**Class II permissive change Request**

Model: E600Mini

Brand : PAX

Pursuant to CFR § 2.1043, PAX Technology Limited hereby requests a Class II permissive

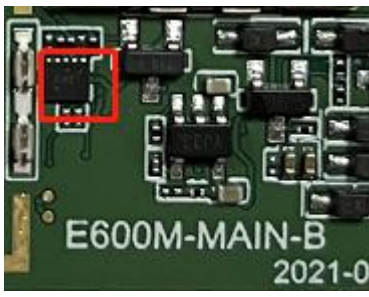
2			<p>Change the layout of the conductor.</p>
3	 <p>E600M-MAIN-B 2022-09-</p>	 <p>E600M-MAIN-B 2021-0</p>	<p>Change the voltage-level translator IC.</p>
4	 <p>E600M-2.4G/5G/1.575GHz-V03-SY</p>	 <p>E600M-2.4G/5G/1.575GHz-V03-SY</p>	<p>Change the WIFI/BT/GPS antenna.</p>
